PARTS & SERVICE NEWS

REF NO.	AT01187A
DATE	Jan. 18, 2002

SUBJECT: MODIFICATION TO PREVENT INTERFERENCE OF HOSES AND HARNESSES FOR HYD. CIRCUIT ON HM400-1

PURPOSE: To introduce modification procedures to prevent interference of the hydraulic circuit hoses and the harnesses on HM400-1 dump trucks

Fig. 19

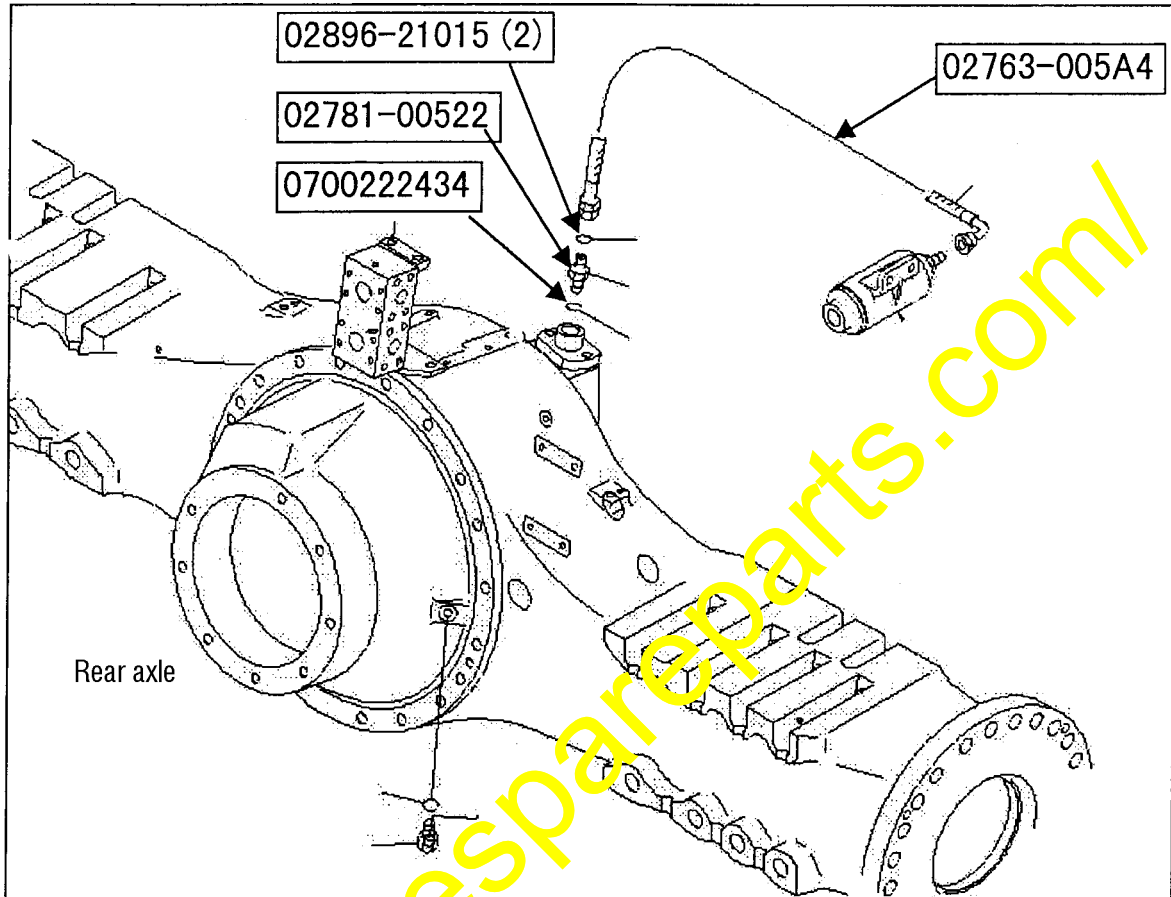
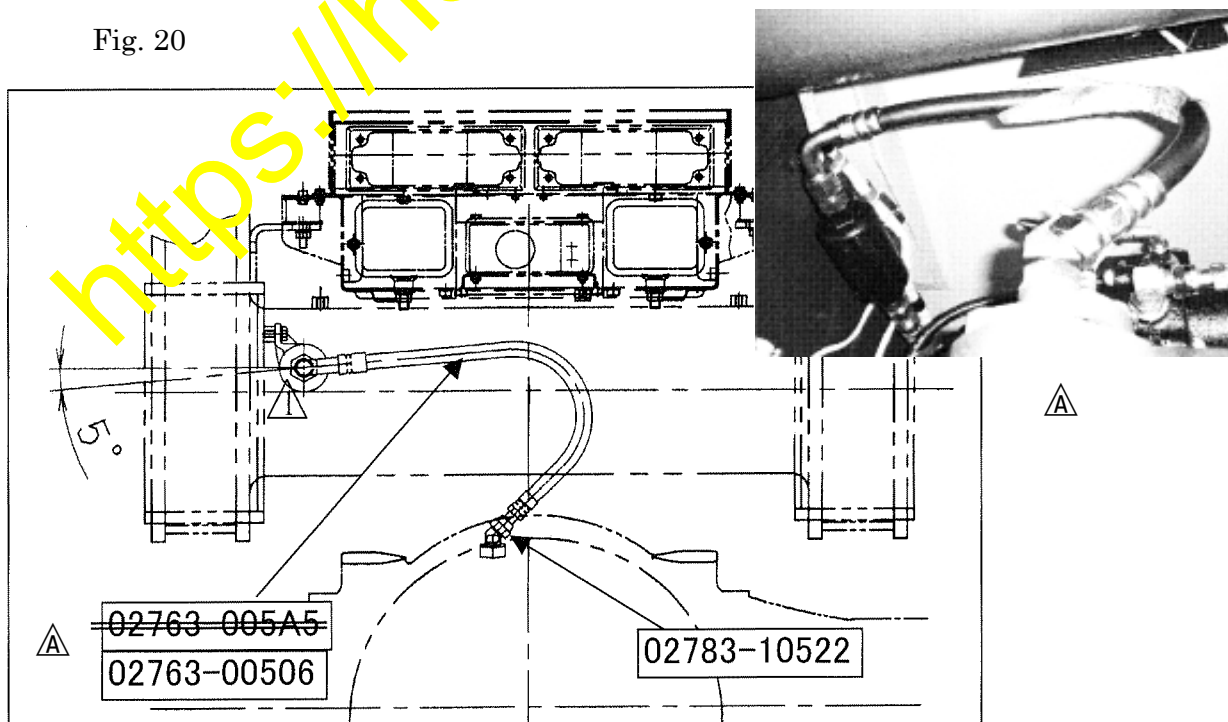
- 4-8. Modification procedures for the rear axle dif. lock hose (Refer to Fig. 19 and Fig. 20.)
- 1) Replace the union (02781-00522) with the elbow (02783-10522).
 - 2) Replace the hose (02763-005A4) with the hose (02763-005A5). Replace the O-rings (07002-22434) and (02896-21015) with new parts at the same time.

Fig. 21

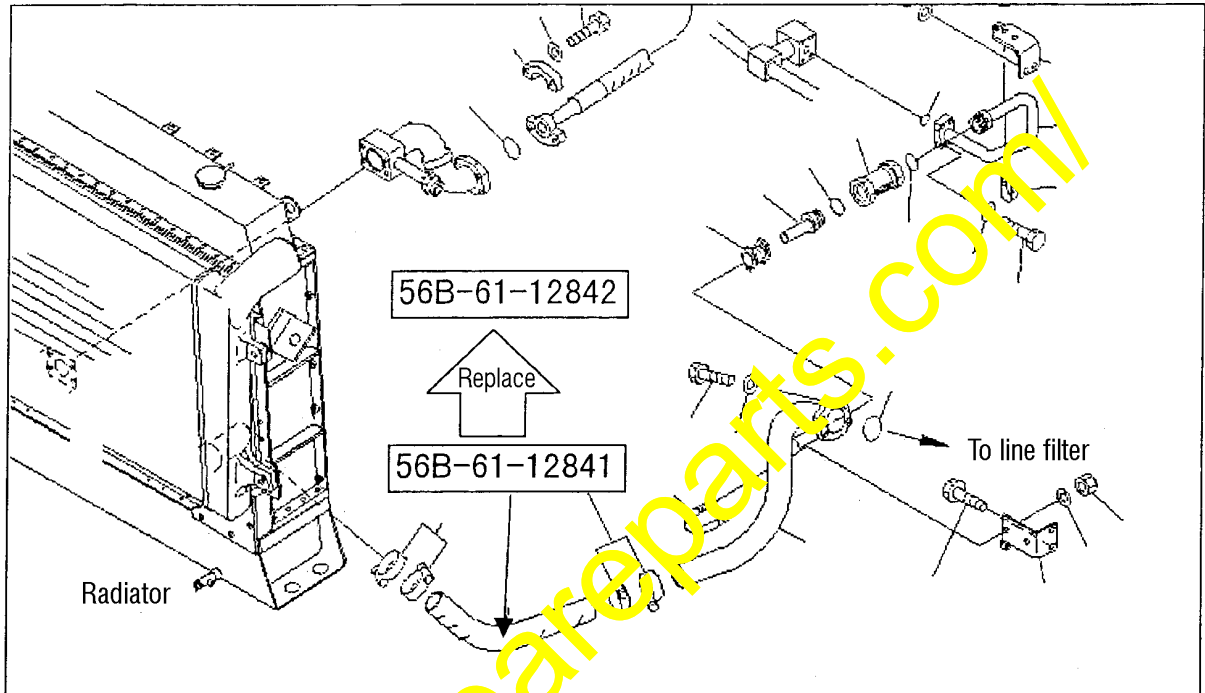
- 1) Replace the hose (56B-61-12841) with the hose (56B-61-12842) developed for the modification.

(Since the current hose is a defectively produced hose, replace it with the correctly produced hose.)

Fig. 22

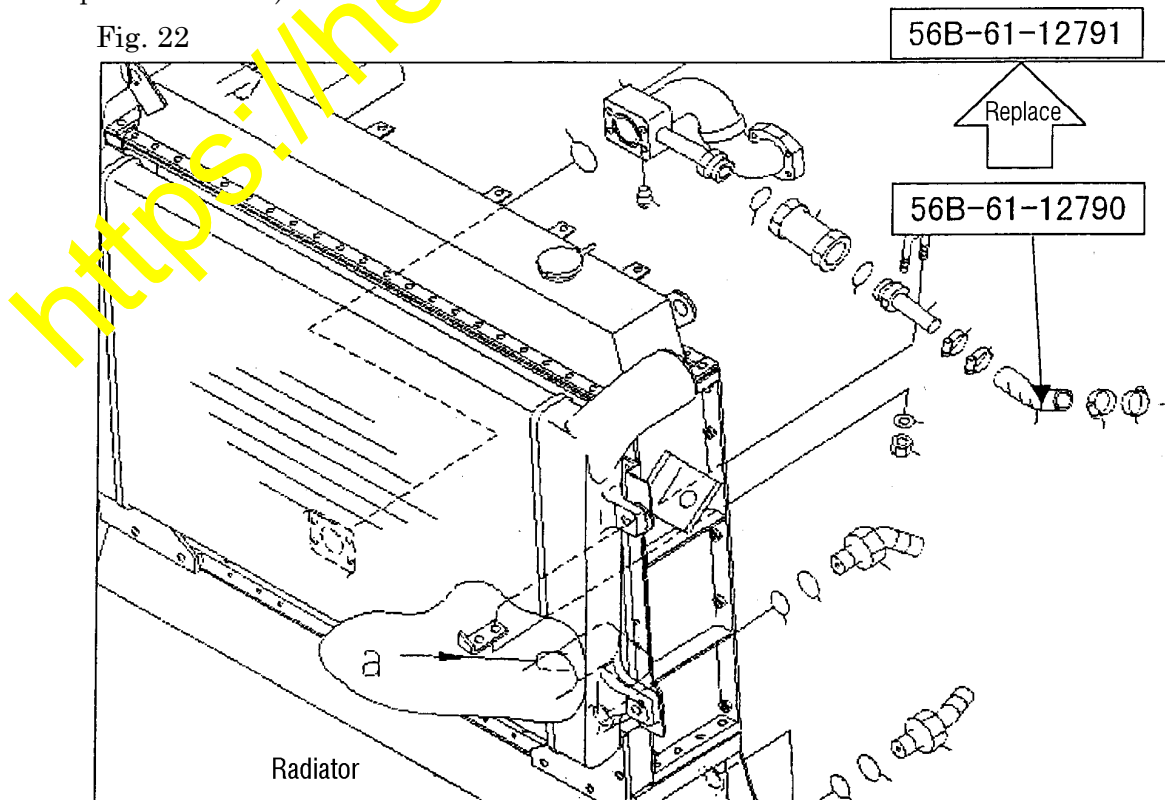
- 2) Replace the hose (56B-61-12790) with the hose (56B-61-12791) developed for the modification.

(Since the current hose is a defectively produced hose, replace it with the correctly produced hose.)

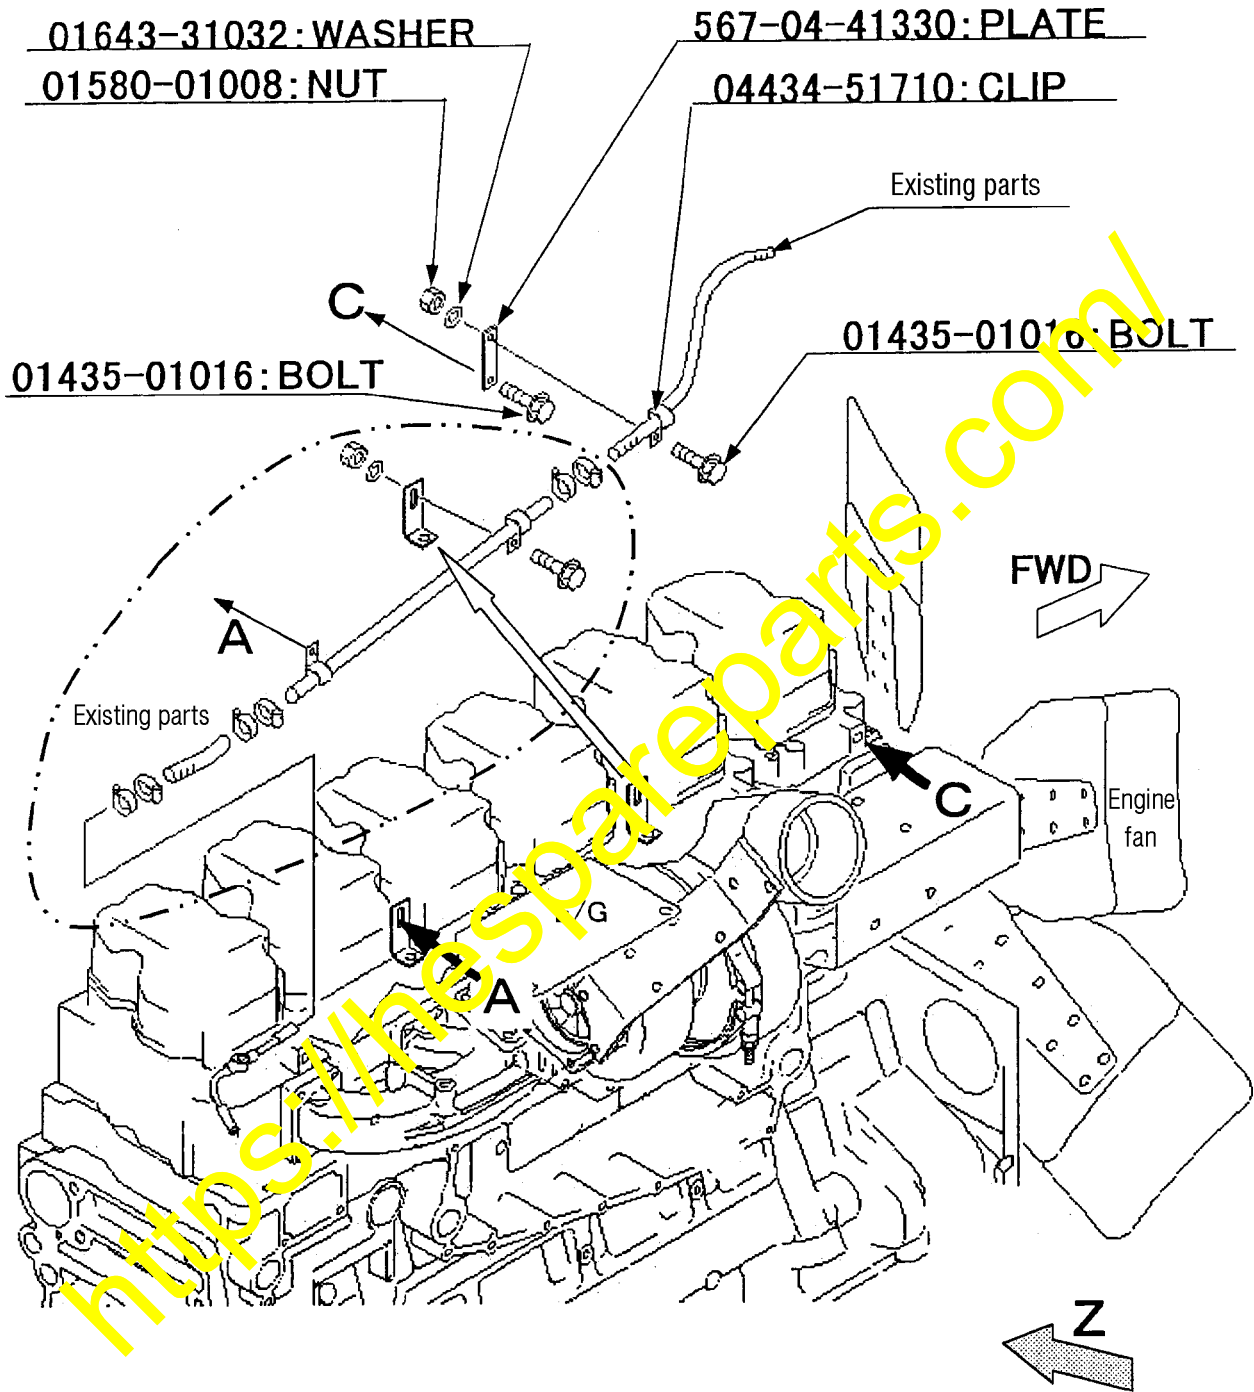
4-10. Modification procedures to add the clamp for the radiator aeration hose

Add the clamp using the parts shown in the schematic diagram shown below.

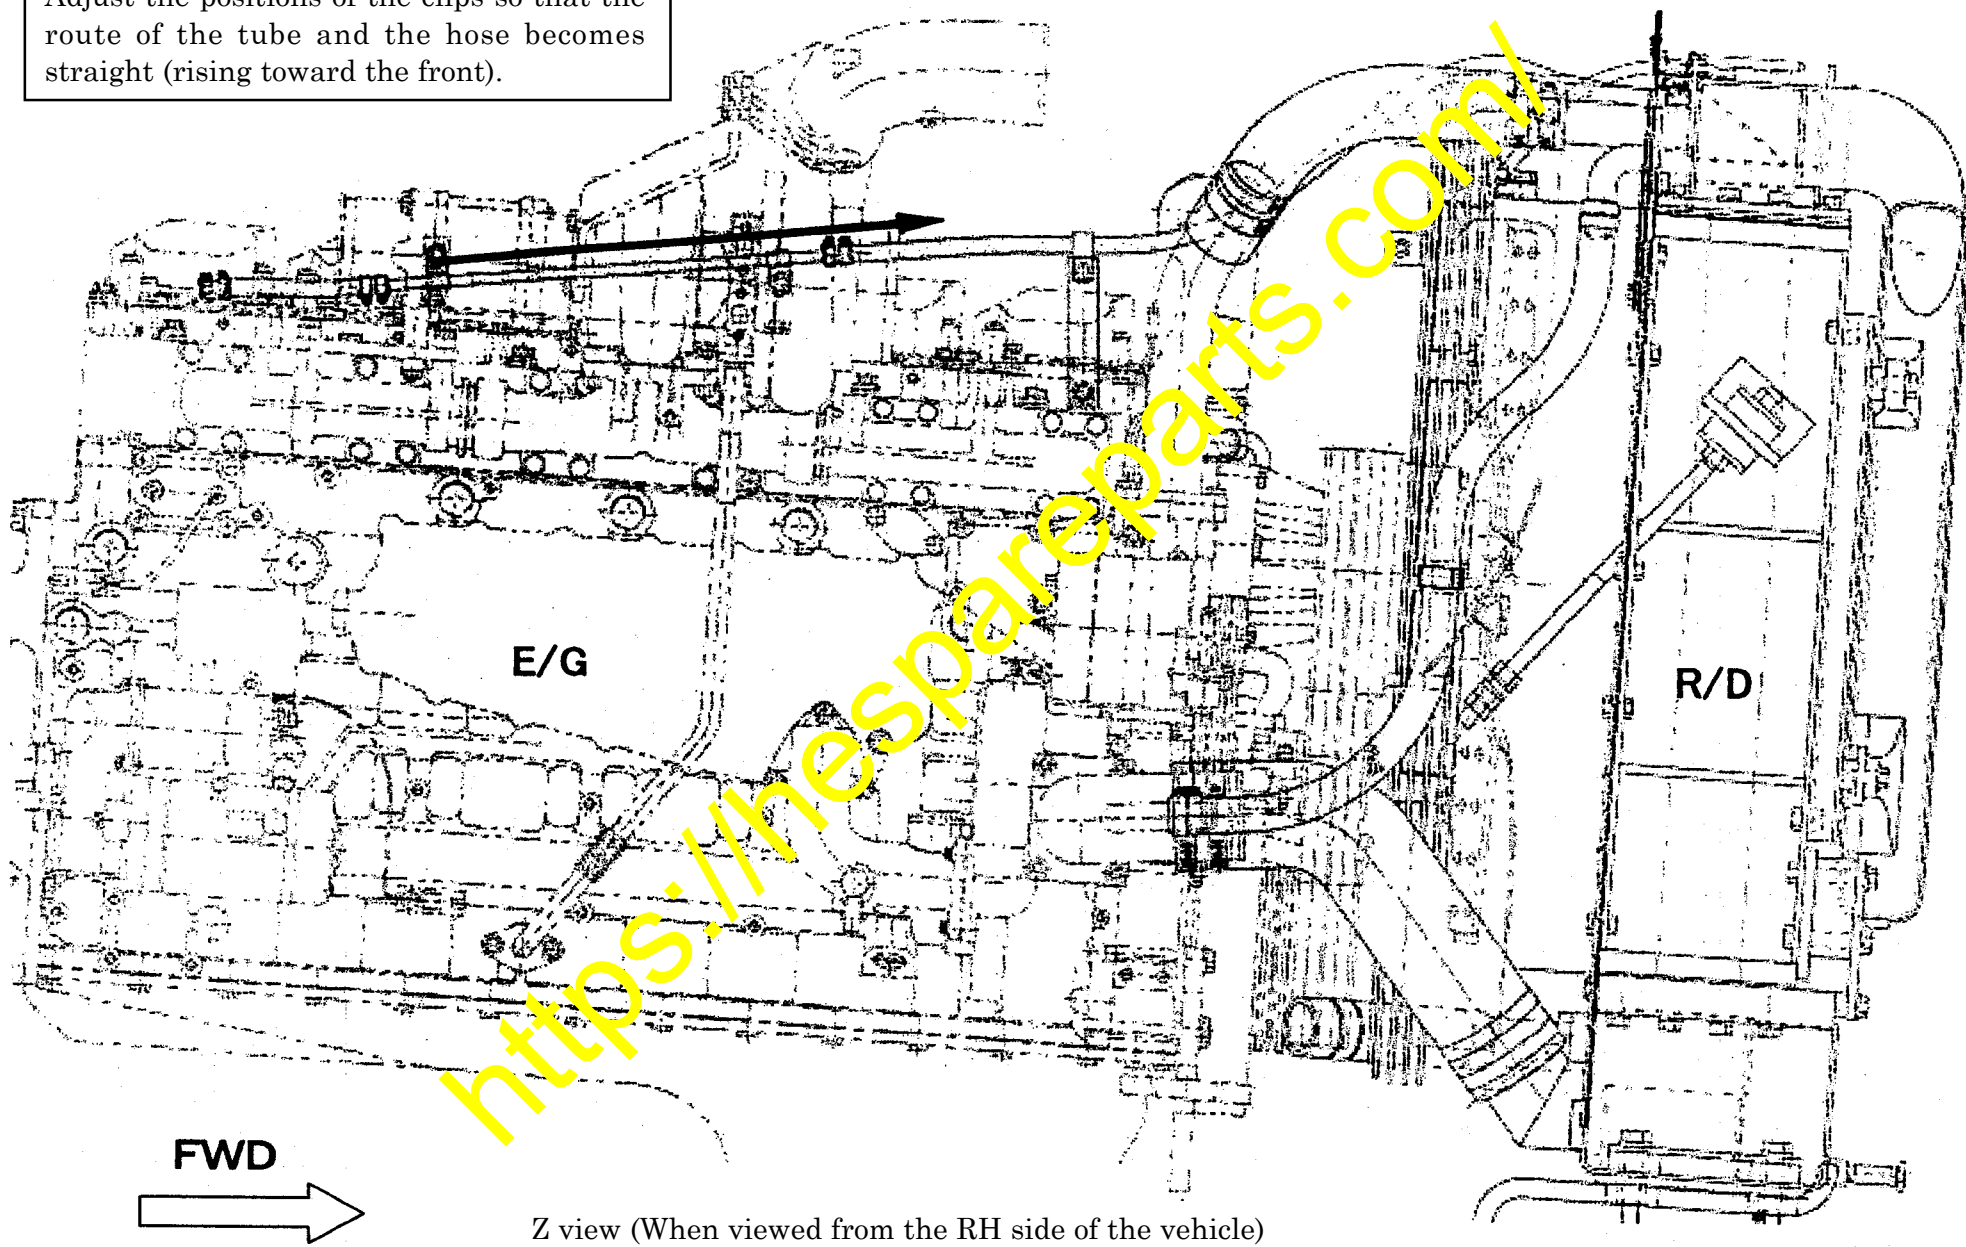
Adjust the positions of the clips so that the route of the tube and the hose becomes straight (rising toward the front).

- 1) Remove the brake tubes (56B-43-17866 and 56B-43-17876) of the rear axle to change them to the improved tubes (56B-43-17867 and 56B-43-17877).
- 2) Refer to Fig. 24 regarding the fastening method for the tube.
